# PrintServer 17/600 Printer

## Maintenance Advisory

EK-PRT17-MA. A01

**First Printing, March 1994**

Figure 2–1 New V2.1 Controller Board Test Patterns

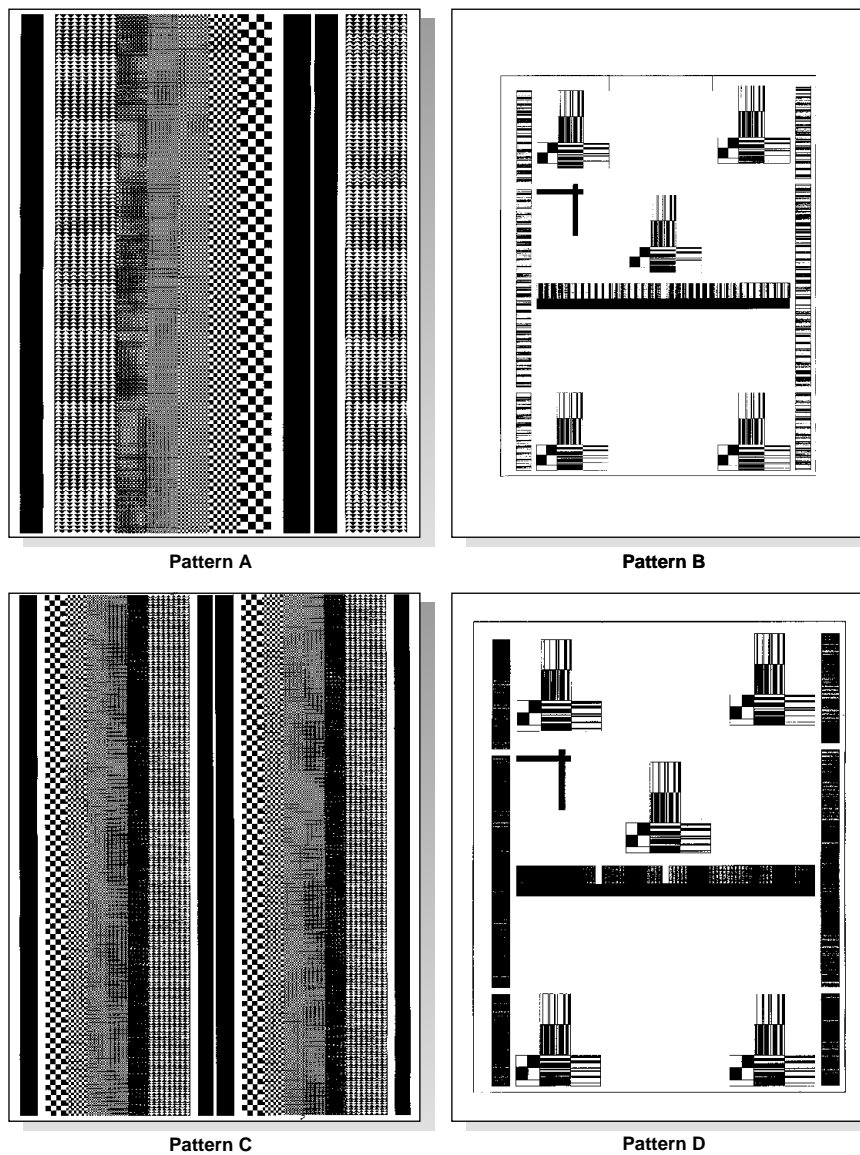
Figure 2–1 shows the 400 and 600 dpi test patterns that are printed by a PrintServer 17/600 printer. An example of the PrintServer 17 300 dpi pattern appears in Figure 4-2 of the service guide.

**Note under Figure 4-2.**

- Patterns A and B are printed at 400 dpi. Compare the B and D test test patterns. Notice how the B pattern is smaller on the page than pattern D. This only happens at 400 dpi.
- Patterns C and D are printed at 600 dpi. Compare the C and the A test patterns. Notice how the C test pattern is horizontally compressed. This compression effect increases as the density (dots-per-inch) increases.
